AG Sciences Building
Bakersfield College – Bakersfield, CA

TETER Project No.: A 20-11707 D

Client Project No.:
DSA File No.: 15-C1
DSA Appl. No.: 03-122075

ADDENDUM NO. 1 (ACCESSORY)

ENLARGED ELECTRICAL SITE PLAN

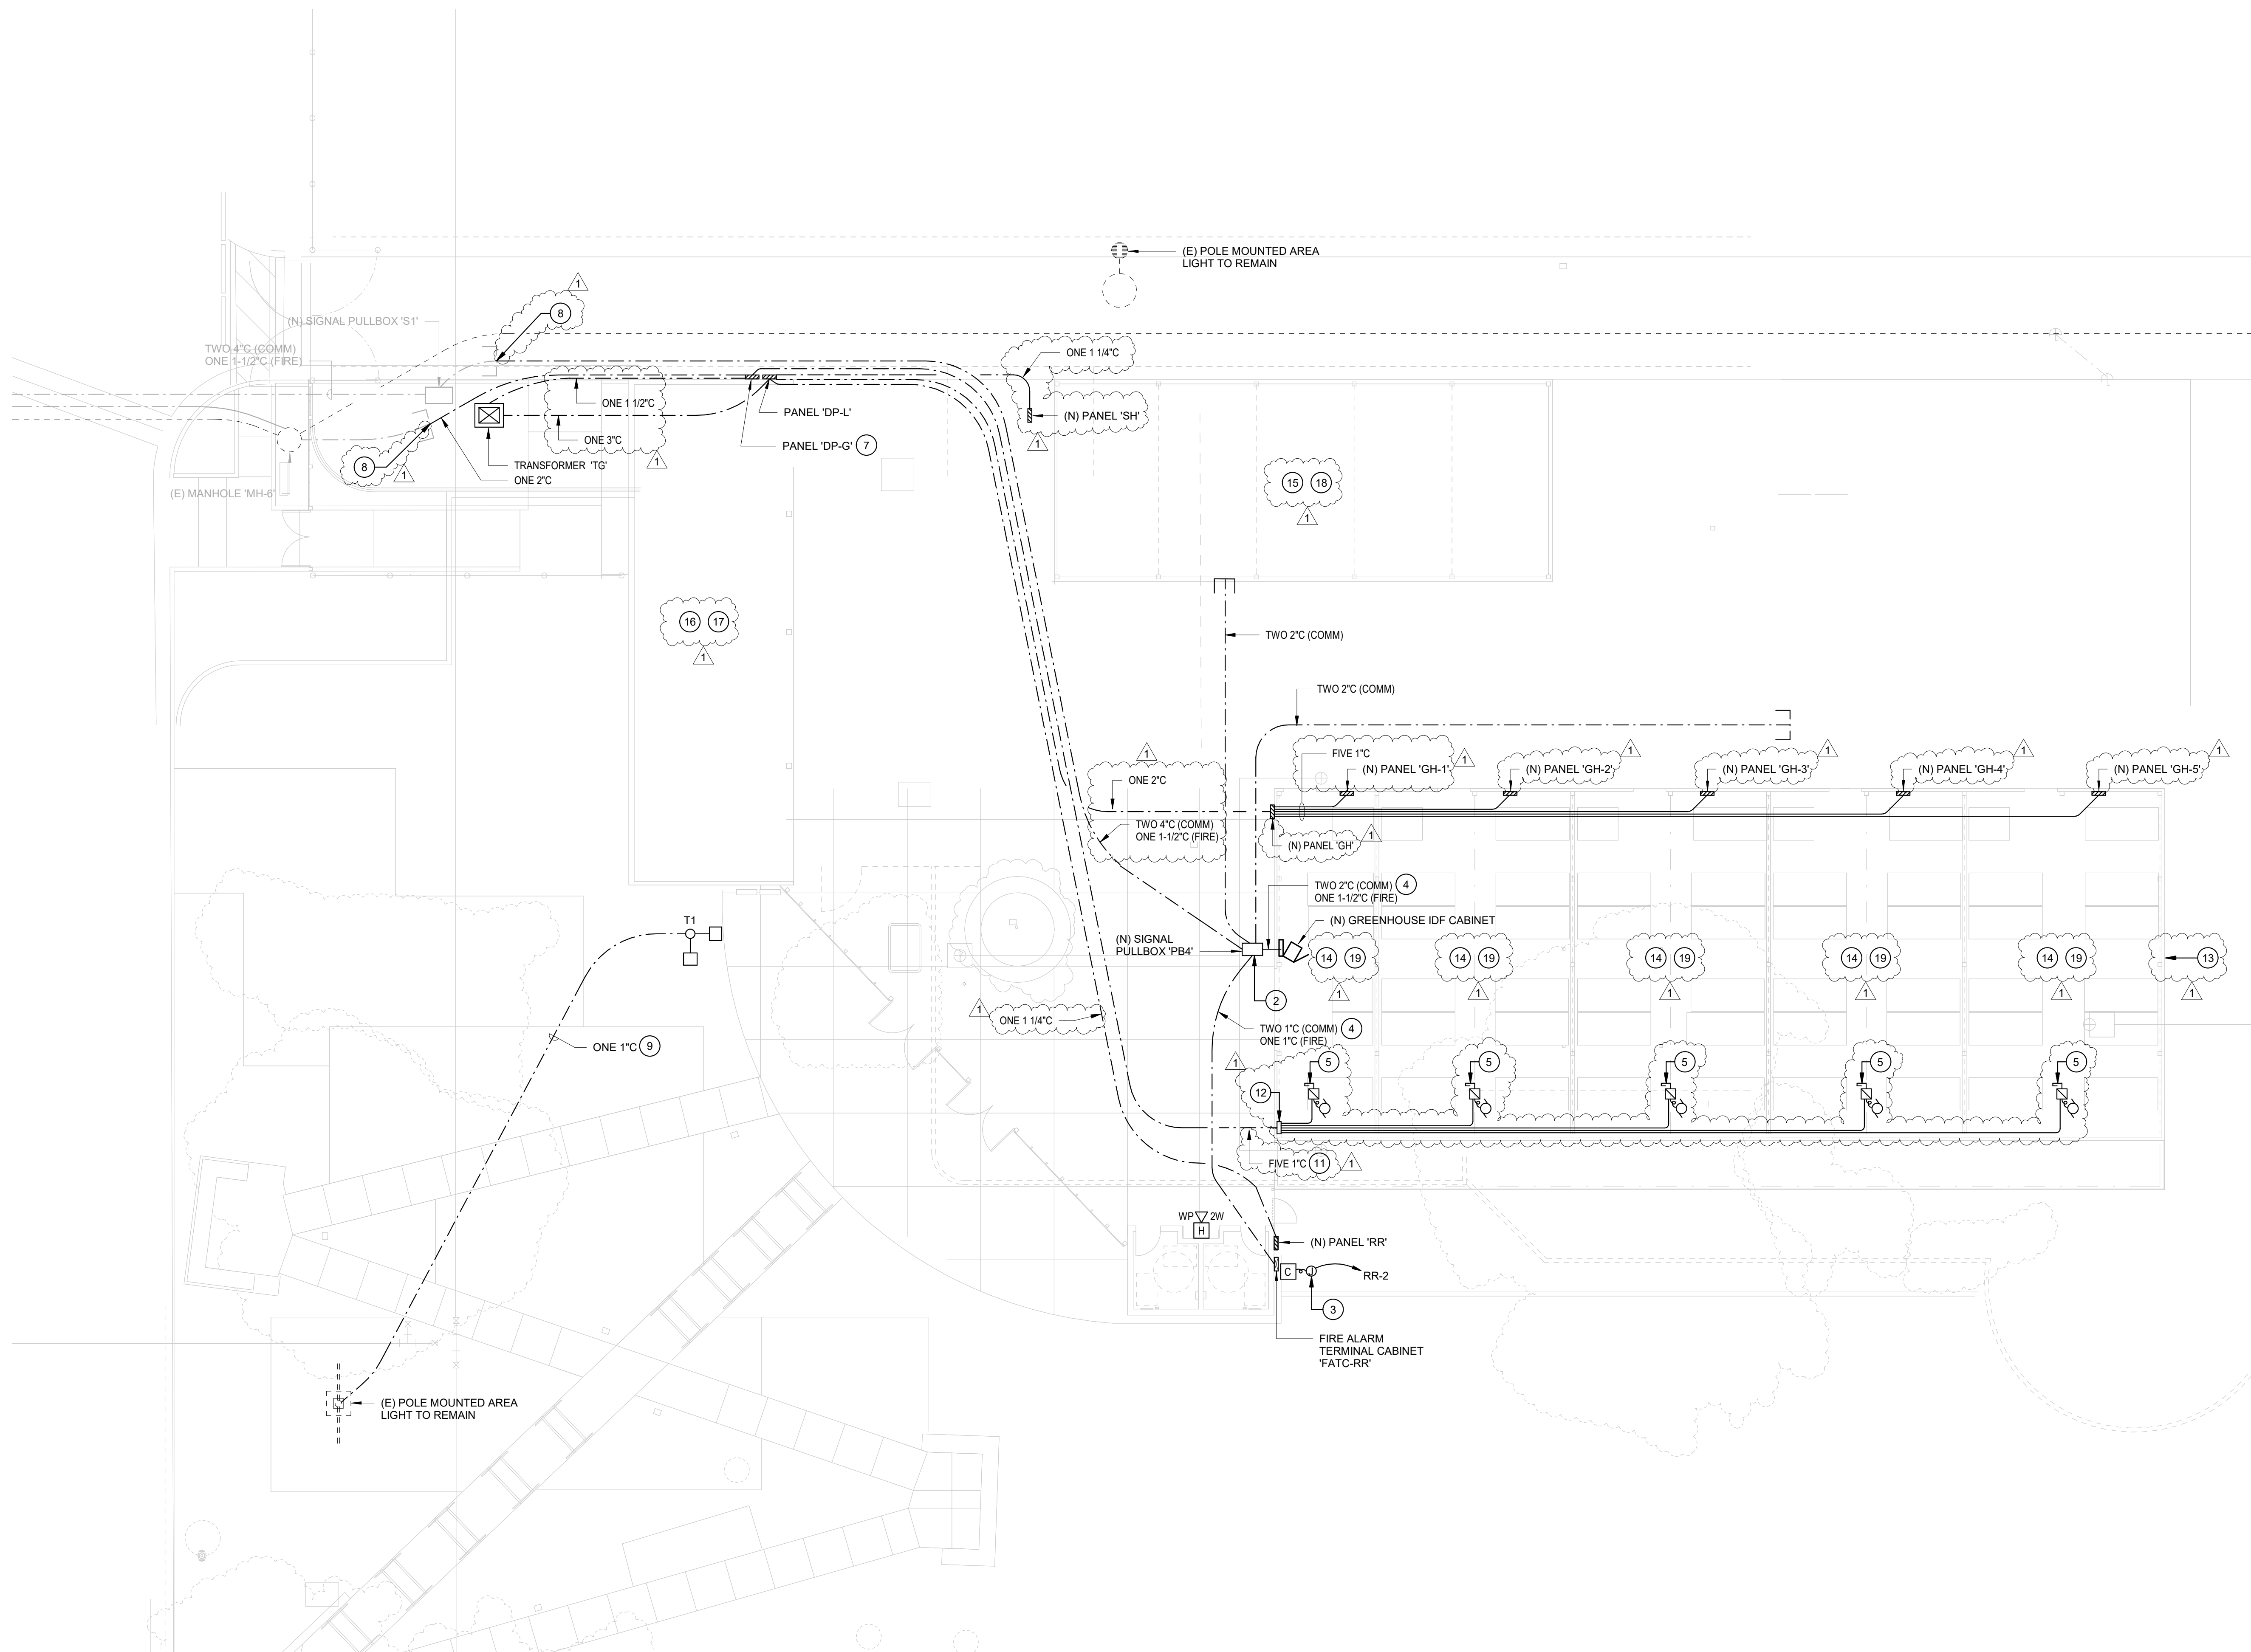
- 1 – 07: DRAWINGS, SHEET E101-AC – ELECTRICAL SITE PLAN**, revise as follows:
- A. Replace Sheet E101-AC – Electrical Site Plan in its entirety. See attached revised Sheet **E101-AC**.

ELECTRICAL SCHEDULES, LEGEND AND NOTES

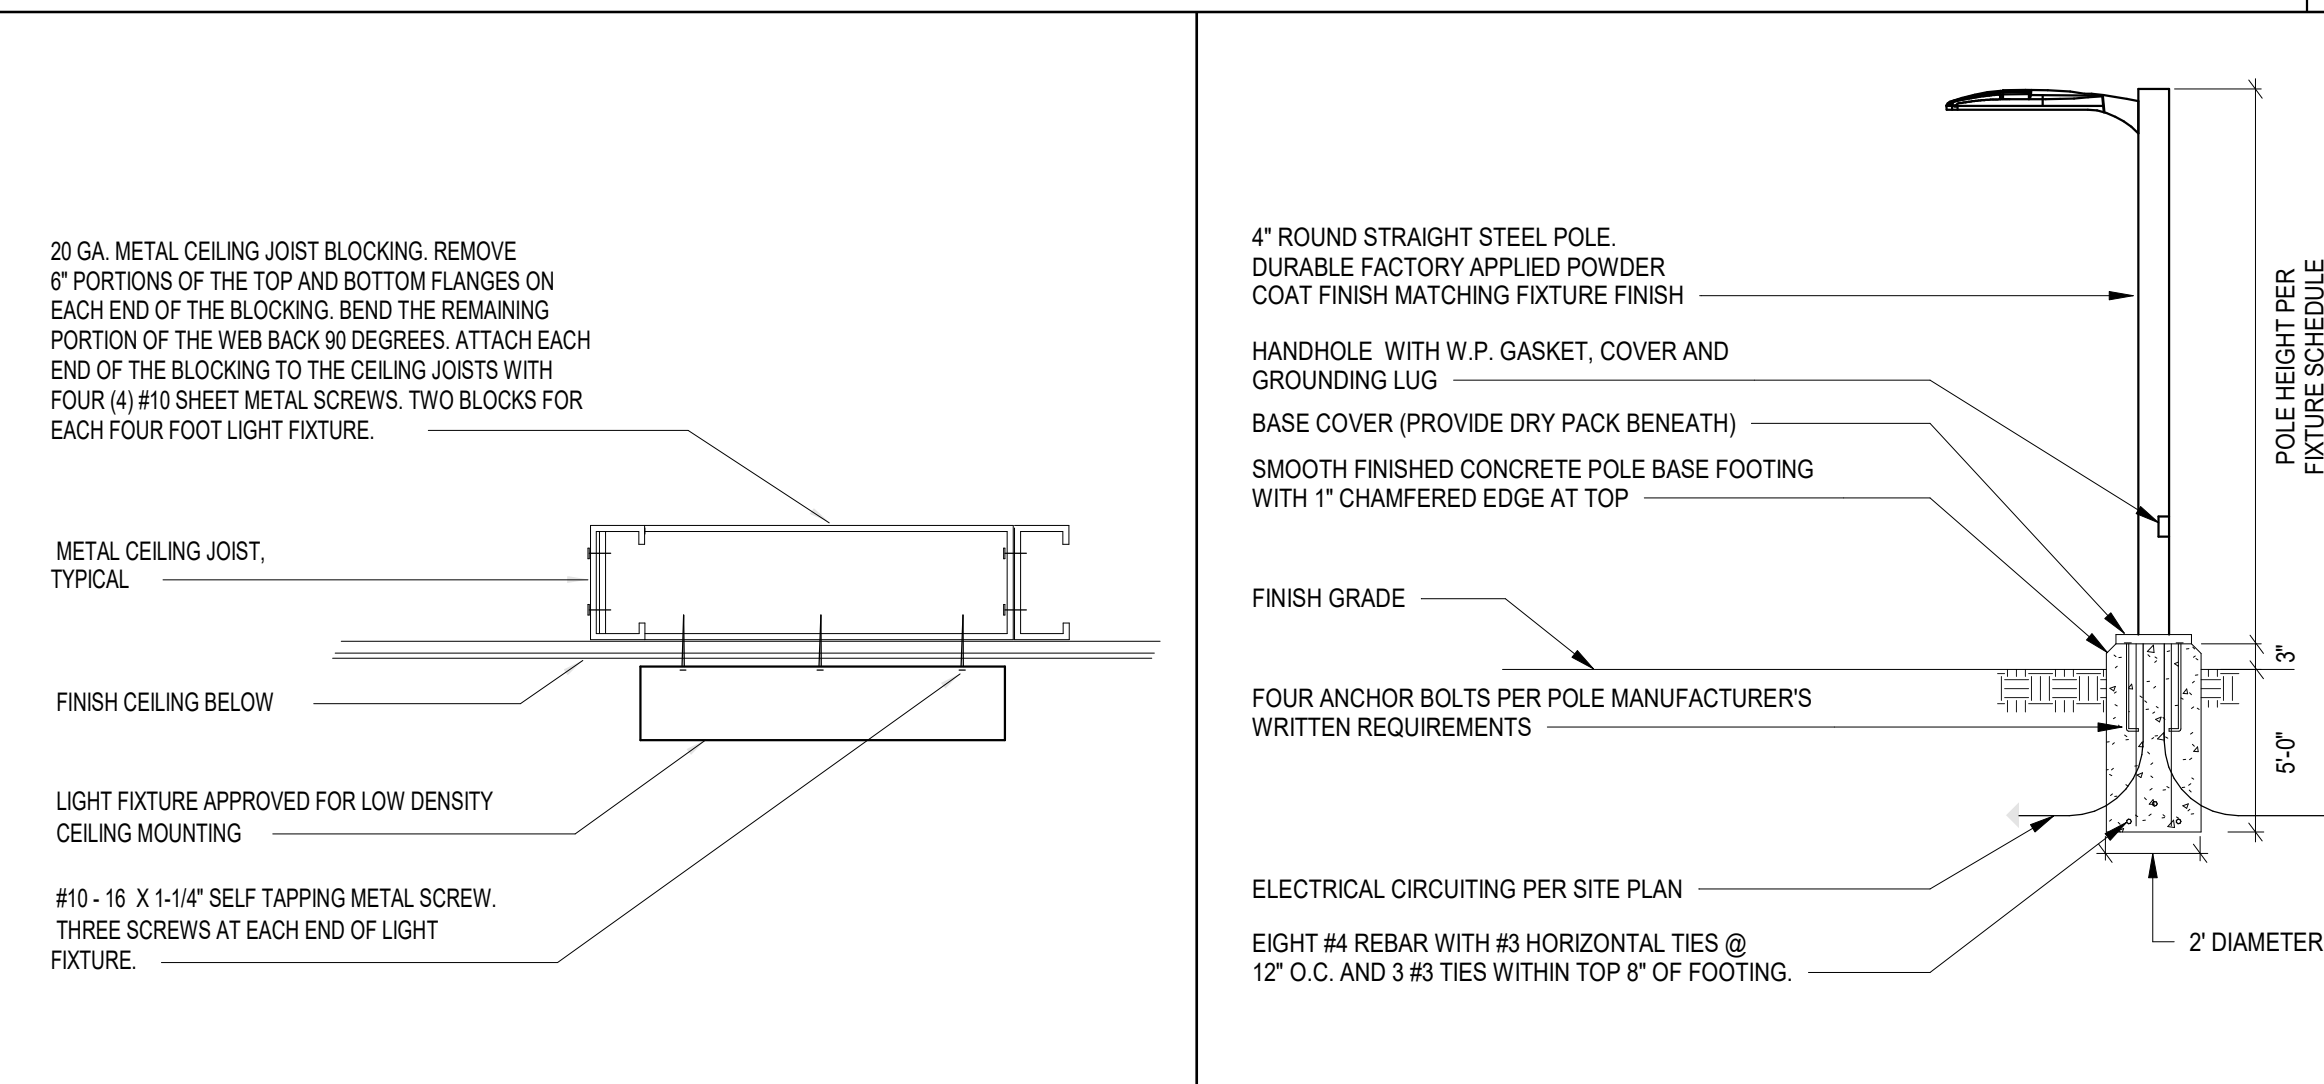
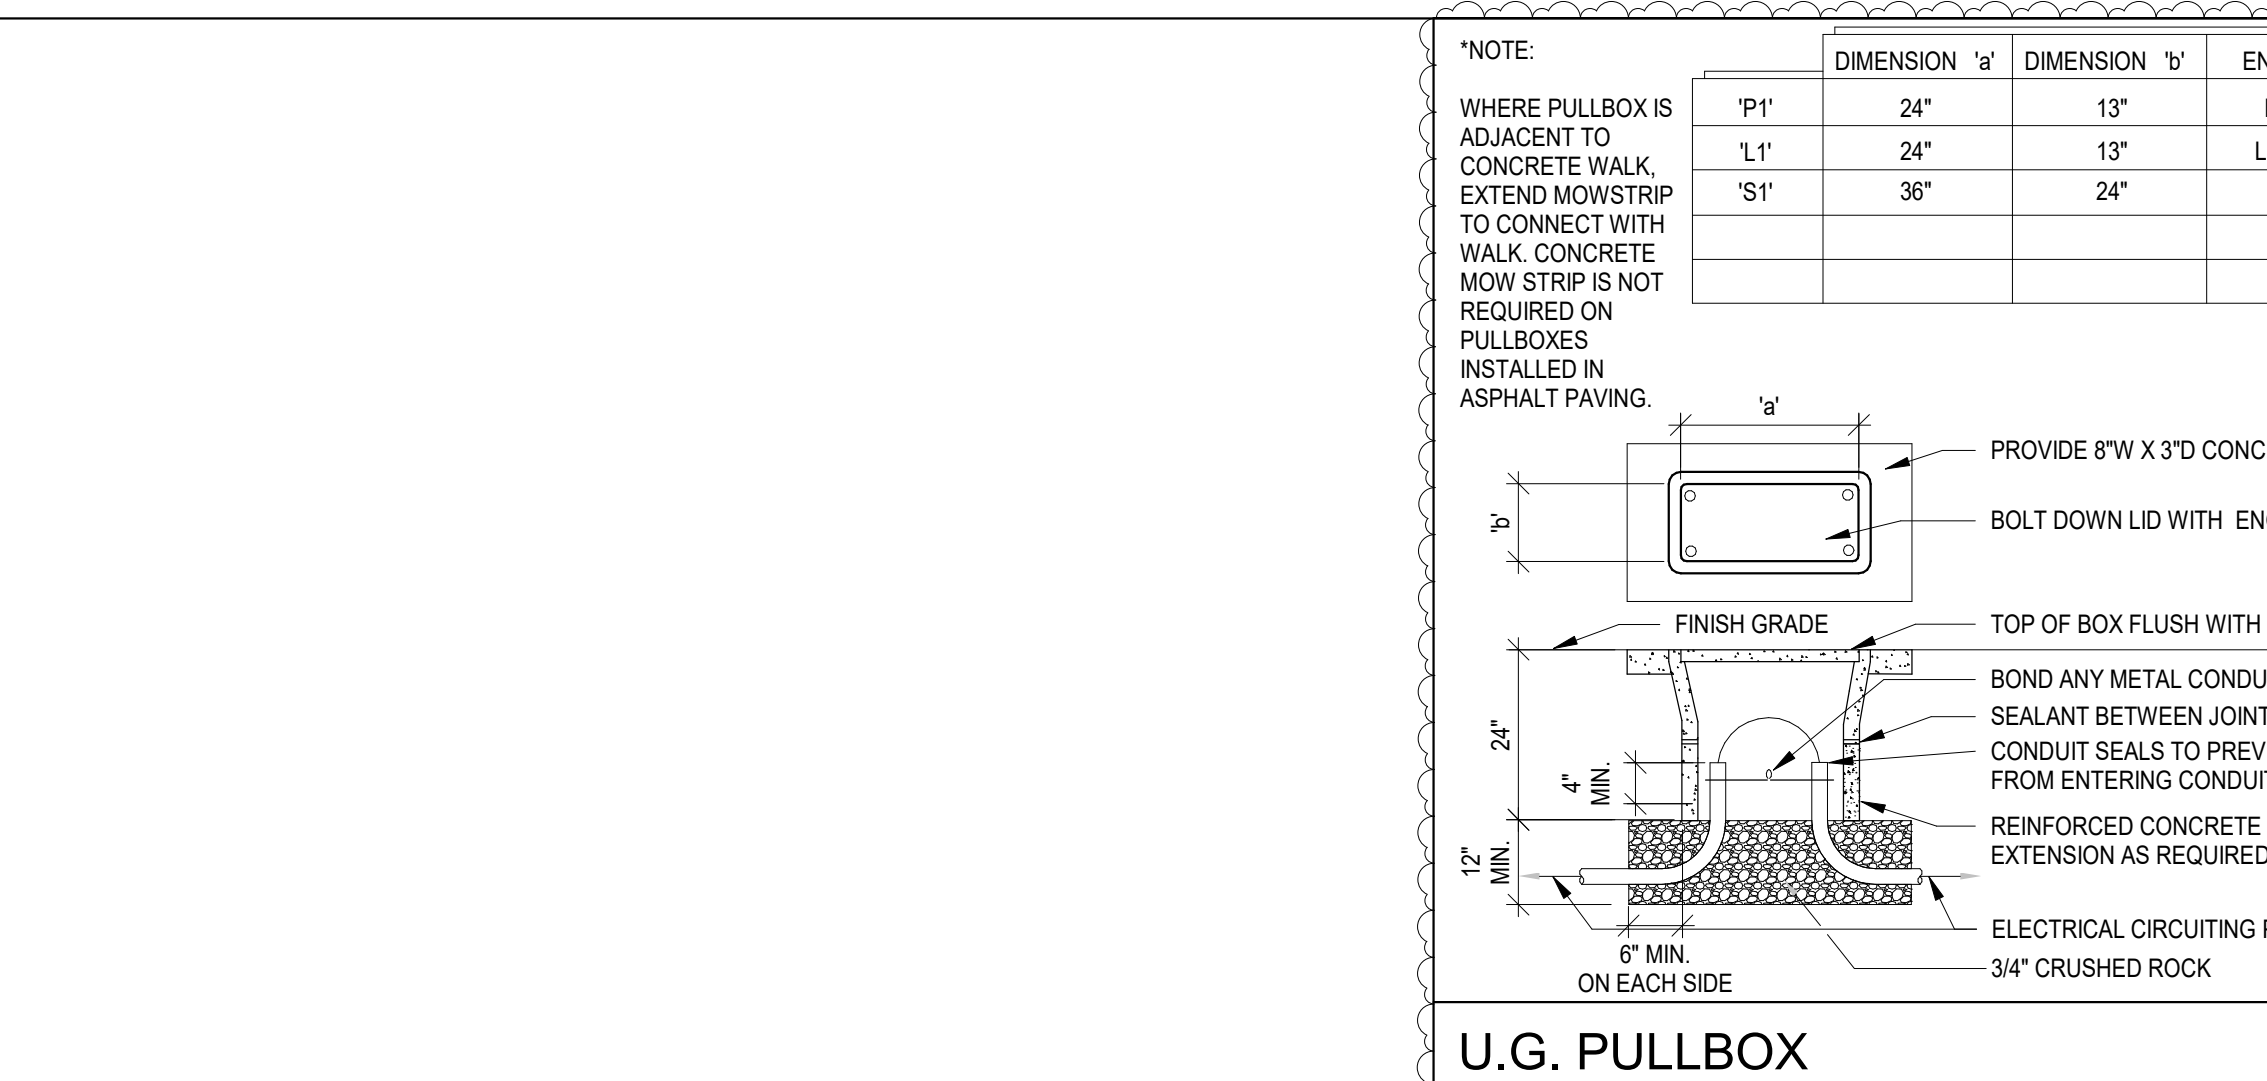
- 1 – 09: DRAWINGS, SHEET E850-AC – ELECTRICAL SCHEDULES, LEGEND AND NOTES**, revise as follows:
- A. Replace Sheet E850-AC – Electrical Schedules, Legend and Notes in its entirety. See attached revised Sheet **E850-AC**
